STAFF REPORT ACTION REQUIRED

Application for Fence Exemption 4 Halbadier Place

Date:	January 21, 2010
To:	Etobicoke York Community Council
From:	Curtis Sealock, Manager, Municipal Licensing and Standards
Wards:	Ward 3, Etobicoke Centre
Reference Number:	09-172269 FEN 00 IR

Attachment 4: Site Plan showing the Proposed Fence

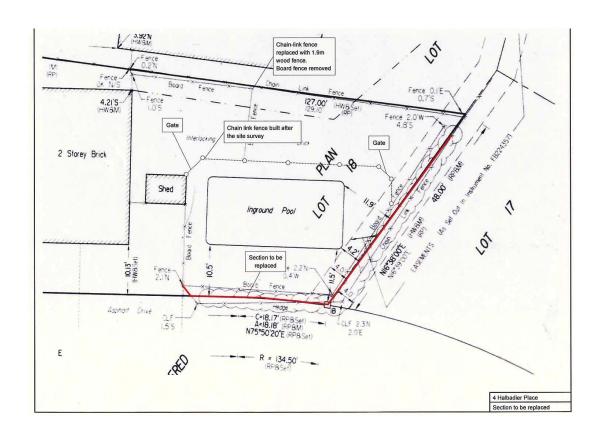
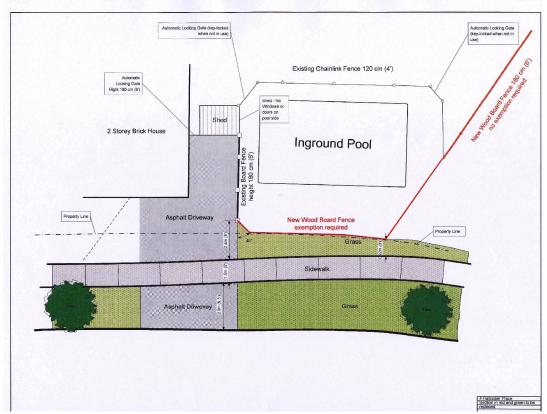
As the hedge is allegedly too high for maintenance (Attachments 2, 3, 4 and 6) and it is partly encroaching on the Halbadier Place road allowance, the owner is planning to remove it completely together with the existing fences on the south side and replace this section of the pool enclosure (together with the portion on the east side abutting 120 Meadowbank Road) with a new close board wooden fence with a lattice top. While the new fence will only be 1.95 metres high measured to the pool deck, it is 2.80 metres high measured from the travelled portion of the sidewalk (Attachment 5), and this is equivalent to an average height of 2.38 metres.

Being on a corner lot on the side with the longer property line abutting a street (Attachments 1 and 6), the proposed fence on the south side is located on the flankage yard as defined in the By-law. The maximum height of a fence at the flankage yard of a single residential property within 2.4 metres of side lot line and within 2.4 metres of any driveway is 2.0 metres under Table 1 of the said Chapter. Section 447-2C(1) further requires any fences within 2.4 metres from a driveway to be of open construction for at least 2.4 metres from the lot line at which the driveway begins so as not to obstruct the view of the boulevard or highway. The proposal for this Fence Exemption request will result in a close board wooden fence, instead of one of open construction, within 2.4 metres from the driveway, and having an average height of 2.38 metres with the lattice top, that exceeds the maximum height permitted by 38 centimetres (15 inches).

Municipal Licensing and Standards recommend that Etobicoke York Community Council refuse the application, as the proposed fence does not comply with the provisions of Toronto Municipal Code Chapter 447, Fences.

Attachment 5: Section and Elevation of Proposed Fence

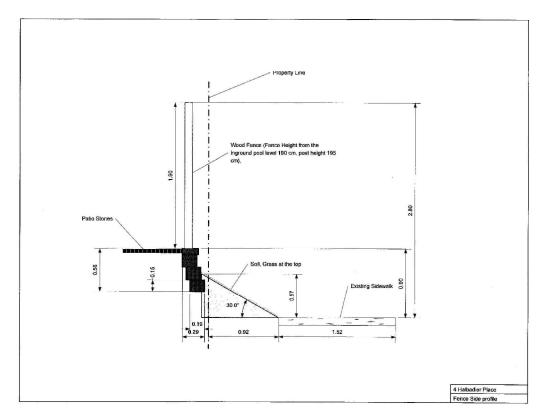
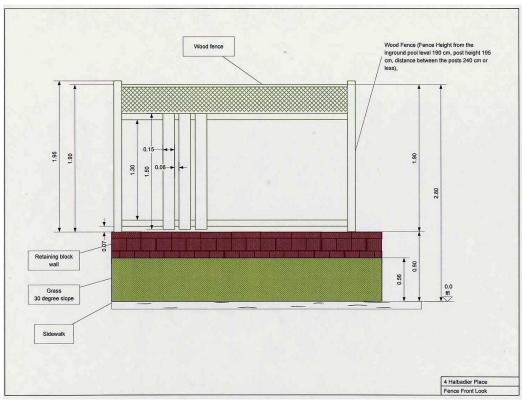
The fence height is taken as any point along the length of the fence from the average grade level measured perpendicular to and one metre away on either side of the fence according to section 447-2B(1) of Chapter 447 of Toronto Municipal Code, Fences. In effect, the average height of the proposed fence is 2.38 metres.
